REGULAR MEETING AGENDA

**Preliminary Site Plan and Special Use Review
For
Ypsilanti Township, Michigan**

Applicant:	Zippy Auto Wash / Corey Weaver
Project Name:	Zippy Car Wash
Plan Date:	June 2, 2025
Location:	1822 W. Michigan Ave. (W. Michigan Ave. and Ellsworth intersection)
Zoning:	RC, Regional Corridor – Form Based District
Action Requested:	Preliminary Site Plan and Special Use Approval

RE: Zippy
Preliminary Site Plan Review #1

Perimeter Parking Lot Landscaping

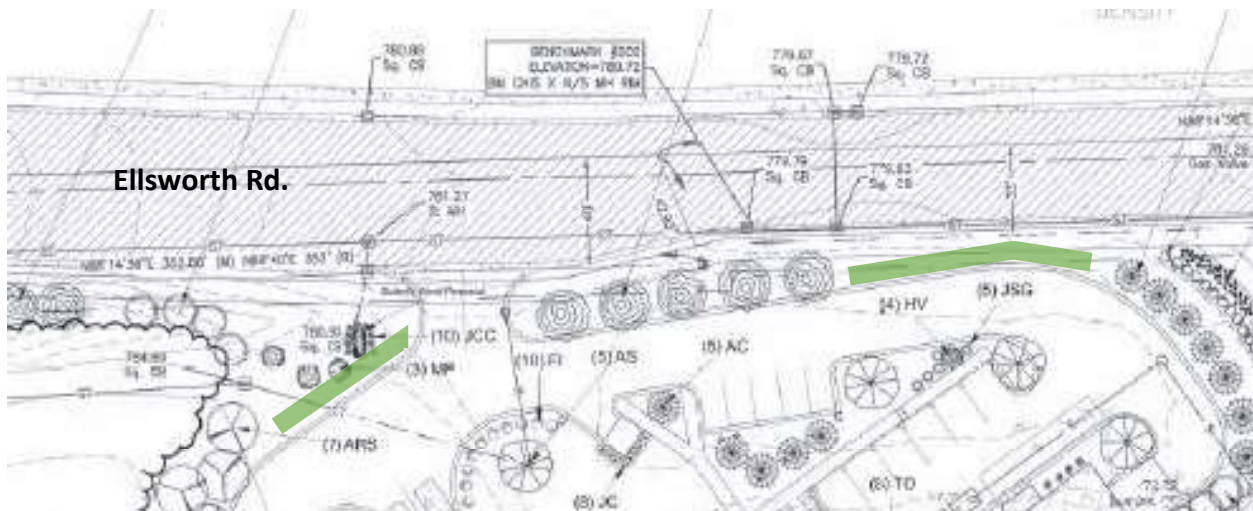
The Landscape Requirements Chart on the Landscape Plan does not indicate that any parking lot perimeter trees have been proposed. We acknowledge that with the other requirements, it may be difficult to locate additional trees on the site. The ordinance gives the Planning Commission the ability to waive or modify the standards of Sec. 1301, *Landscape Requirements*, where the addition of new landscape material would serve no good purpose. While we don’t see space for additional trees, 3-foot-tall shrubs along the maneuvering lane along Ellsworth Rd. could be installed to screen the vehicle lane from view of the road. The Planning Commission should discuss this alternative. The proposed locations (shown in green) are illustrated below:

LANDSCAPE PLAN

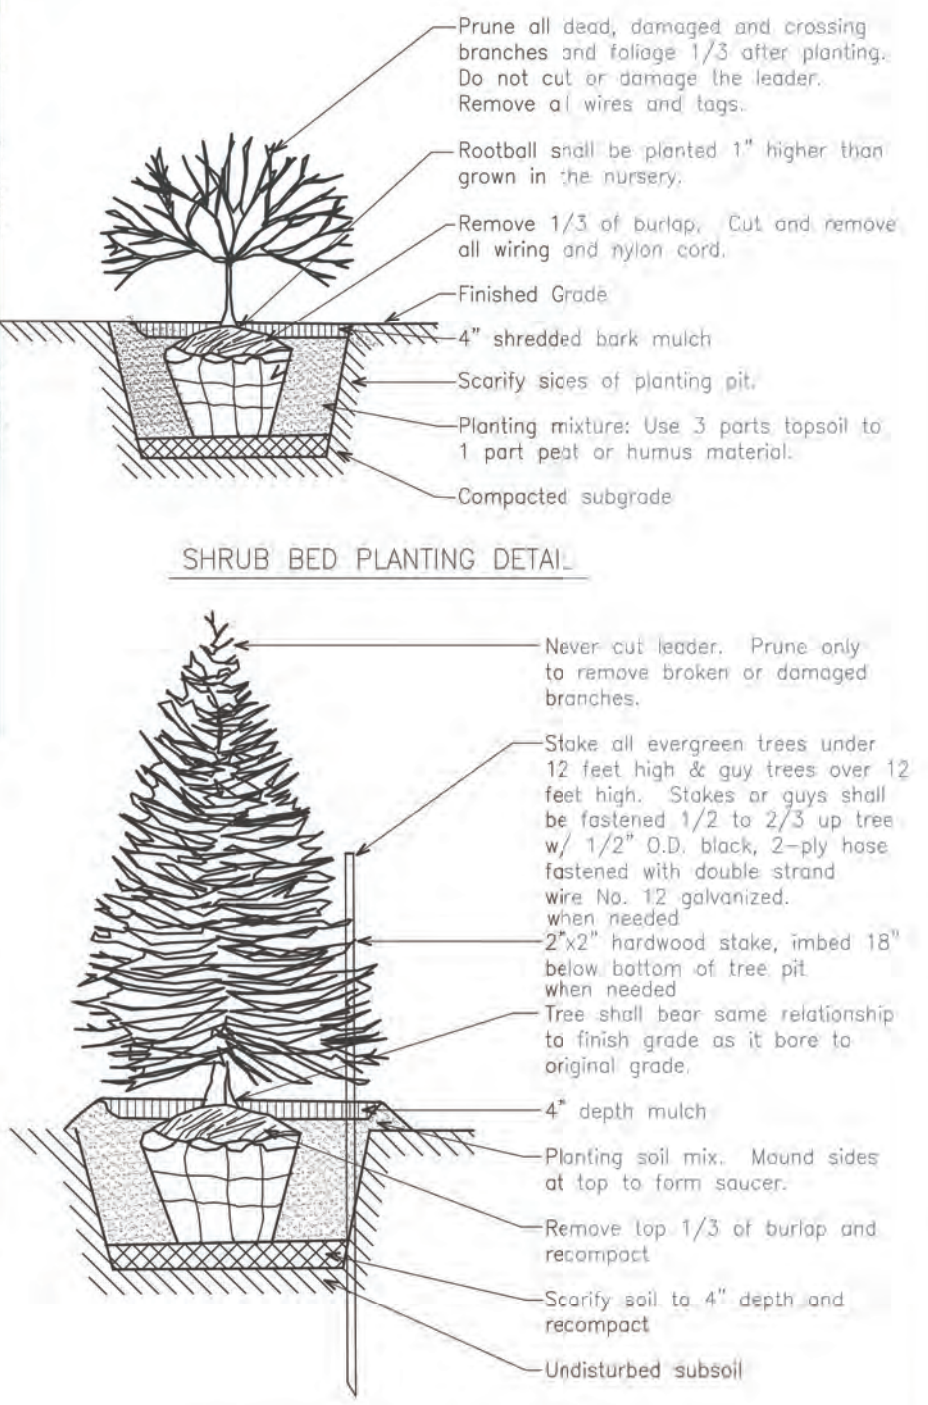
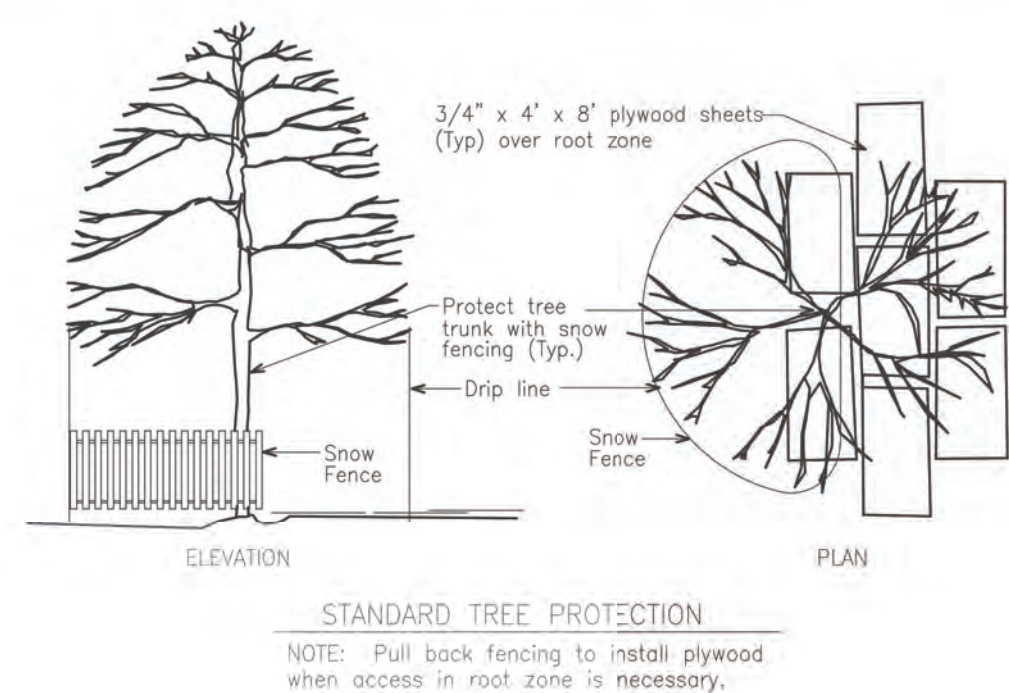
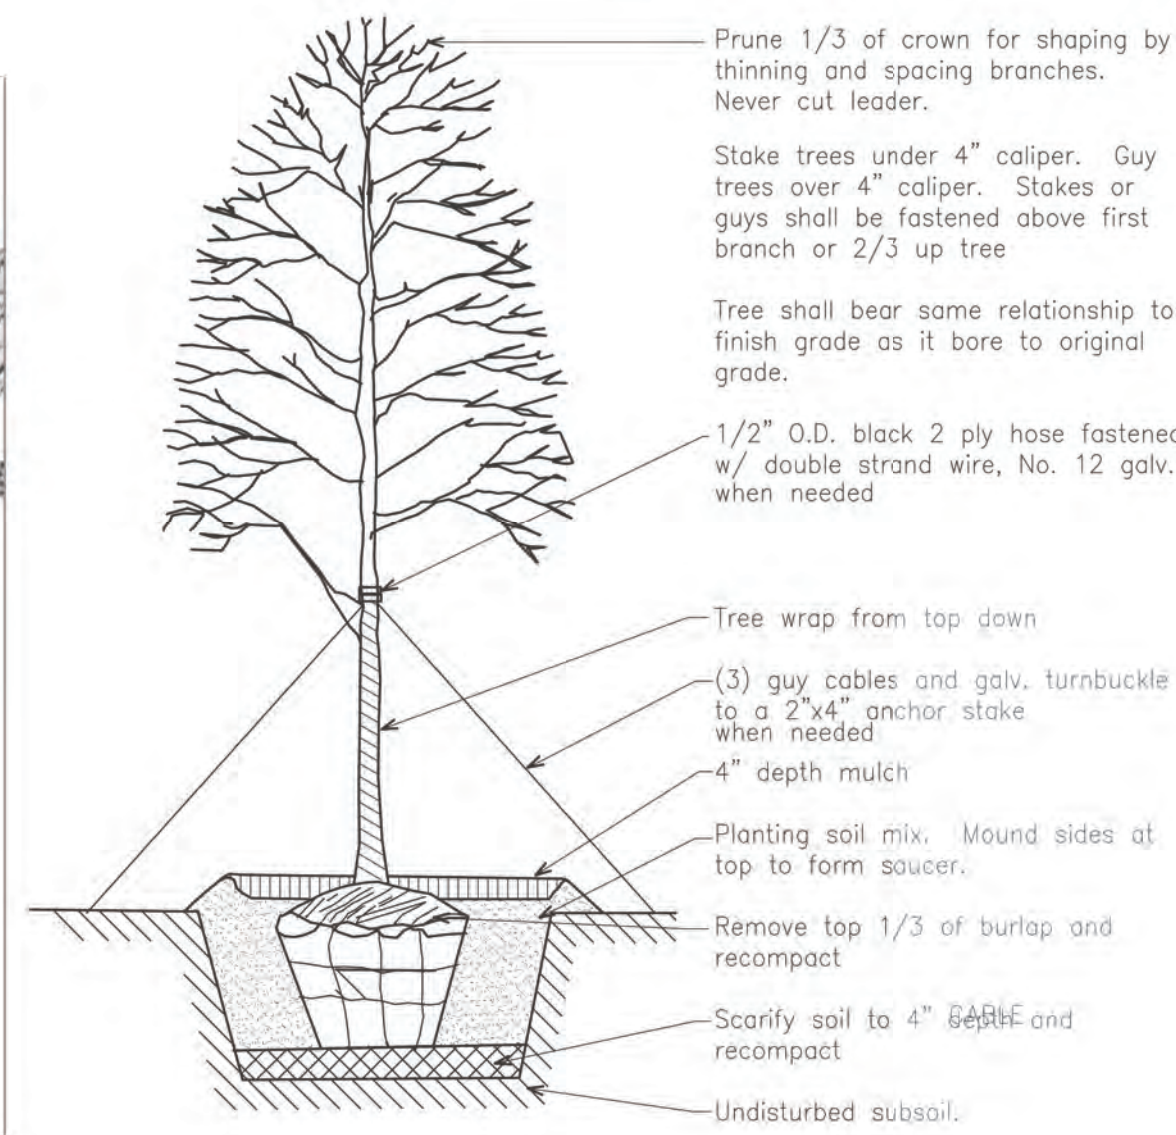
Sheet C-6, *Landscape Plan*, shows preservation of a large, vegetated area along Ellsworth Rd. between the car wash and the residence to the west. It also shows a staggered line of 16 Norway Spruce trees along the west property line adjacent to W. Michigan Ave., between the car wash and the vacant residential lot to the west. The Planning Commission may consider the proposed landscape screen sufficient as an alternative to a 6-foot-tall wall. If landscaping isn't sufficient on its own, the Commissioners may also consider additional alternatives (such as a fence in addition to the landscaping) if necessary.

The proposed sizes of the plant material meet the minimum ordinance requirements, except for the "Show Off" Forsythia. This plant should be at least a 5-gallon container to meet the minimum height requirement at planting.

Items to be Addressed: 1) Planning Commission to consider requiring shrubs along the northerly maneuvering lane to screen Ellsworth Rd. 2) Increase size of "Show Off" Forsythia to minimum 5-gallon container. 3) Planning Commission to consider alternative dumpster location that is not directly in view of Ellsworth Rd. 4) Applicant to seek variance for locating dumpster screen in a "front" yard.

- 1) *Increase size of “Show Off” Forsythia to minimum 5-gallon container.*
- 2) *Seek variance for locating dumpster screen in a “front” yard.*
